LOV Fryer RTI Update Kit 826-2581

This kit replaces a control-box mounted transformer with a more robust model and routes that power through a time-delay circuit to the RTI solenoid. (See explanation of circuit in figure 3.)

Figure 3

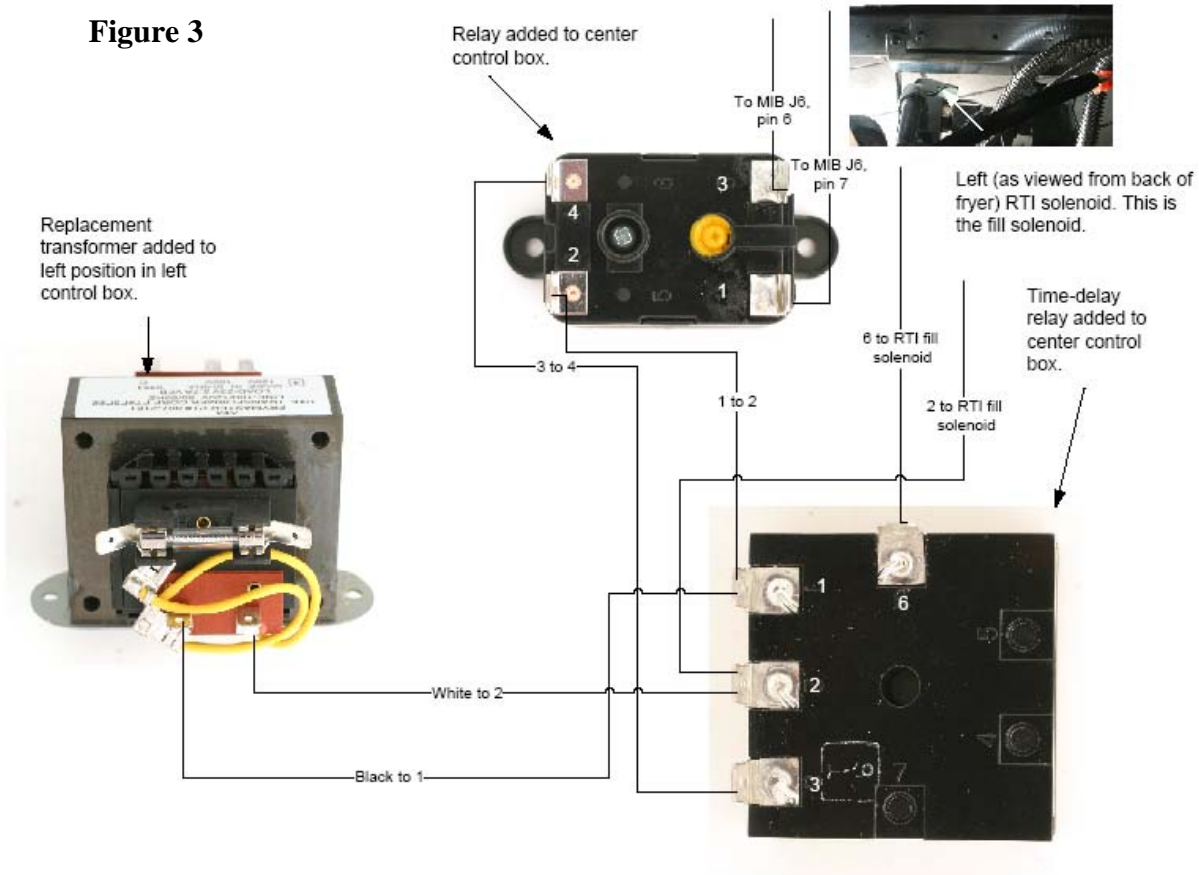
6. Use the two each black wires (six and eight-inch), item 8, to connect the isolating-relay's terminal 2 to the time-delay relay's terminal 1 and the isolating-relay's terminal 4 to the time-delay relay's terminal 3. **See Figure 3.**

9. Insert the bushing in the control box to protect the wiring. **See Figure 2.**
10. Attach the provided 1/4" terminals to the leads from the RTI solenoid and attach them to positions 1 and 3 on the new isolating relay, item 4, in the control box. **See figure 3.**

11. Route the harness, item 1, from the time-delay relay terminals 2 and 6, item 3, to the RTI solenoid. Ensure they don't rest on the drain manifold. **See figure 3.**
